OPEN SOURCE			
Designed by: MM	Approved by: SK	Schematic title: TMC5271–EVAL	Revision: 1.1
Release date: 2023–06–14		Sheet title: REVISION HISTORY	Sheet: 1 / 3

Designed by: MM	Approved by: SK	Schematic title: TMC5271-EVAL	Revision: 1.1
Release date: 2023-06-14		Sheet title: I/O	Sheet: 2 / 3

Supply Connectors

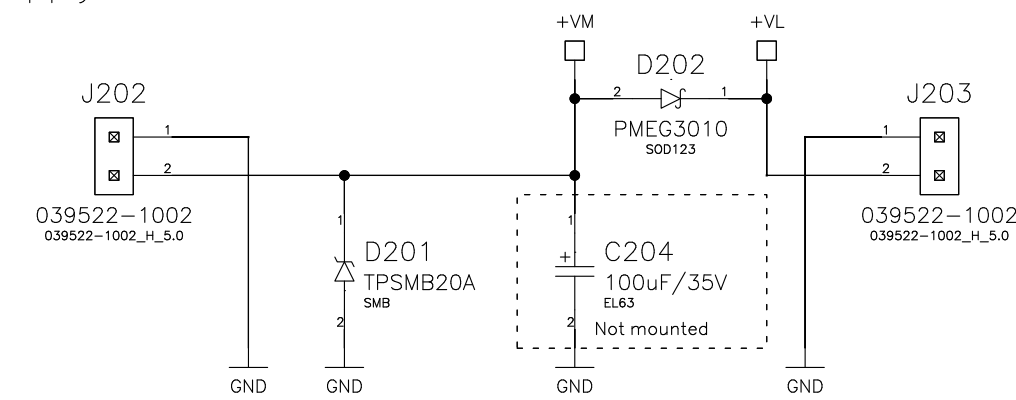
Revision History	
Version 1.0:	First release.
Version 1.1:	J202 and J203 changed from PT115–T330–02 to 039522–1002. J204 changed from PT113–T182–04 to 039502–1004. IC201 changed from MAX8881EUT33 to ADP122–3.3. R301 changed from 20k to 4k7. <u>SLEEP</u> pull–up voltage changed from +VM to +VCC_IO.
